AUBURN HILLS 12TH ADDITION

RE: S/D 00-09 -- Final Plat of AUBURN HILLS 12TH ADDITION

RE: S/D 00-09 -- Final Plat of AUBURN HILLS 12TH ADDITION

STAFF REPORT

AUBURN HILLS 12TH ADDITION

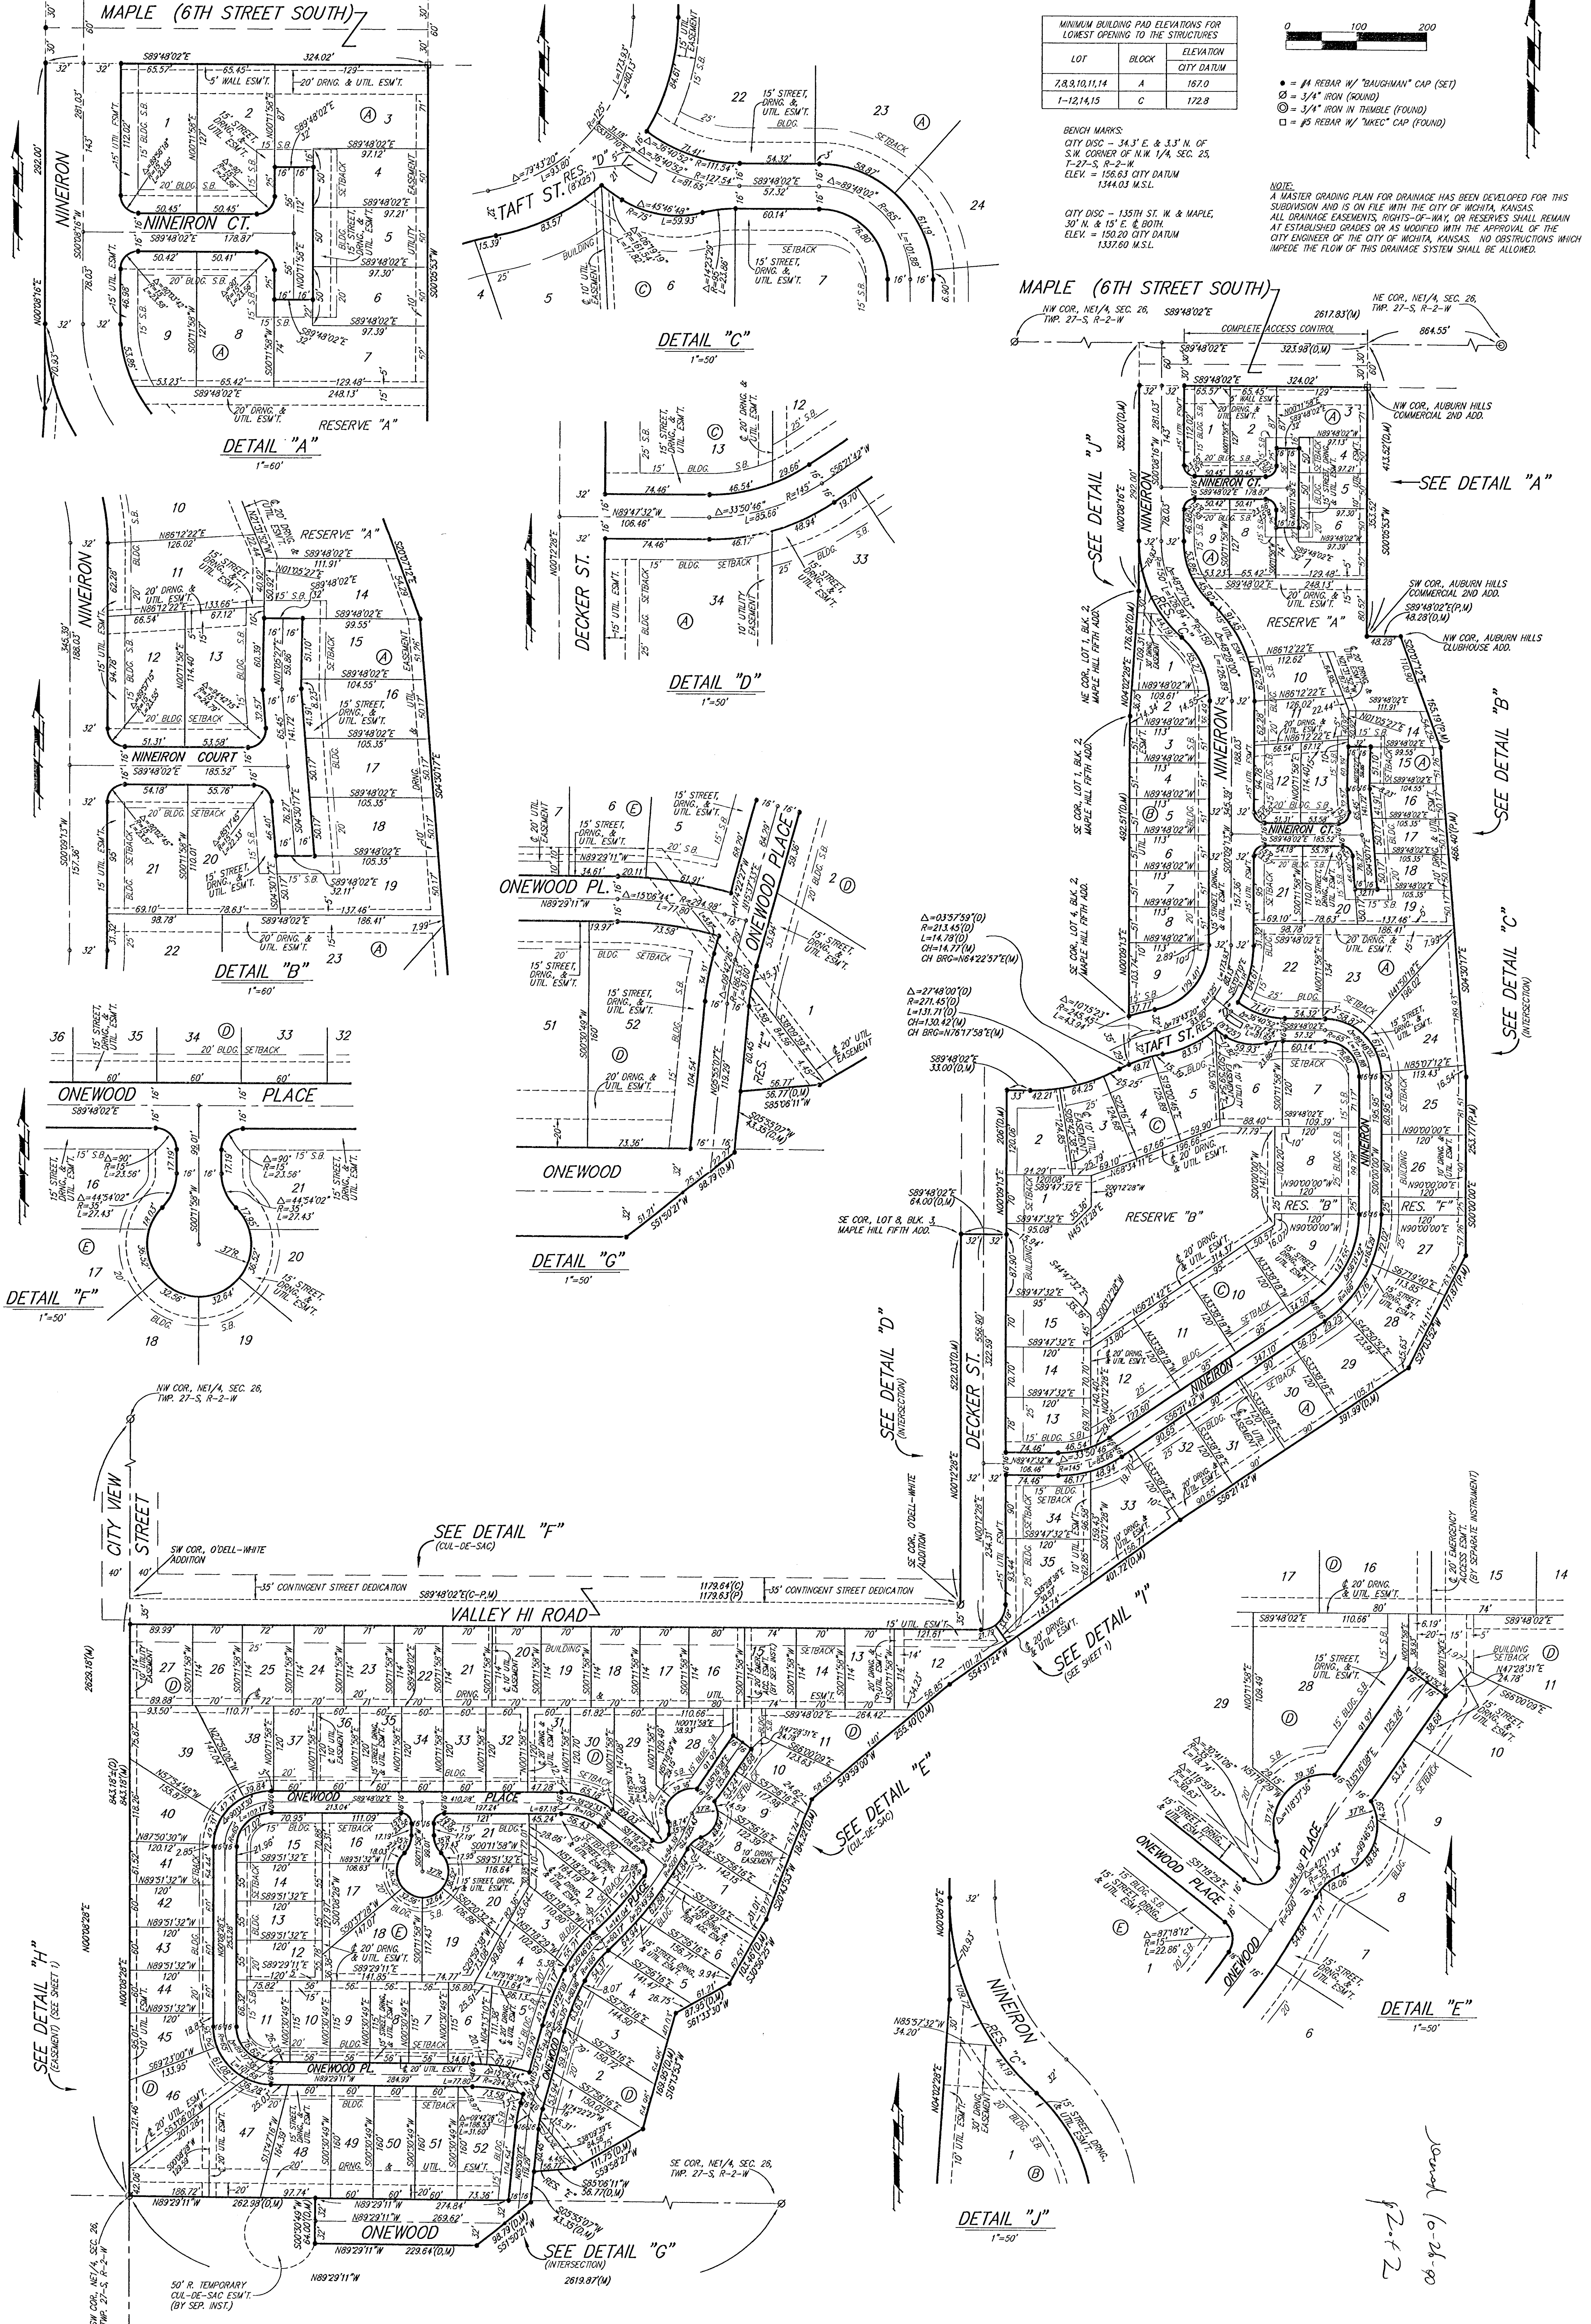
- D. A temporary turnaround will need to be provided at the western terminus of Onewood.
- E. The applicant shall guarantee the paving of the interior streets, Valley Hi Road and the portion of Decker and Taft which adjoins the lots in this plat.

- H. City Fire Department should comment on the acceptability of the plat's street names. Decker Drive should be Decker Street. Nineiron Place should be Nineiron Court.

- I. The Applicant shall dedicate an additional 6 feet of right of way along Valley Hi Road in order to activate the contingent right-of-way dedication along the northern half of the street.

- J. To provide an additional point of access for the lots located on Onewood Place, City Fire Department requests an emergency access easement to connect Onewood Place with Valley Hi Road or Decker.

- P. The definite location of the gas easement needs to be denoted for Lot 47, Block D.
- Q. Dimensions need to be added for the following: Between lots 8 and 9, Block A; the north line of Lots 12 and 13, Block A; west line of Lot 14, Block A; and the south line of Lot 7, Block C. -

- R. The plat's text shall include language that a drainage plan has been developed for the plat and that all drainage easements, rights-of-way, or reserves shall remain at established grades or

as modified with the approval of the applicable City or County Engineer, and unobstructed to allow for the conveyance of stormwater.
